## **DMC-50747NF-AK LCD MODULE TECHNICAL NOTE**

**TN-DMC-50747-01**

**0.0**

**2004/06/06**

Figure 1 -- Block Diagram of Power Supply

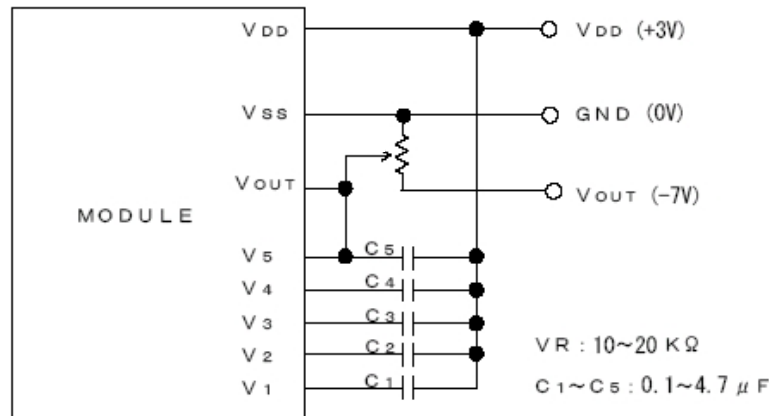
- 3.1. The Section 4.2 Example of Power Supply is not correct. Please refer to Figure 1 for the correct hookup. By varying the potentiometer, LCD contrast can be controlled. Please note that this setup is shown at the bottom of page 4-20 of reference (c) for the instance of 'External Power Supply.'

It is recommended to apply a potentiometer for the contrast adjust due to the tolerance of the driving voltage and its temperature dependence.

Both the boosting circuit and the voltage control circuit are not used in this module. Therefore, connect  $V_5$  pin with  $V_{OUT}$  pin and supply the LCD driving voltage from the outside.
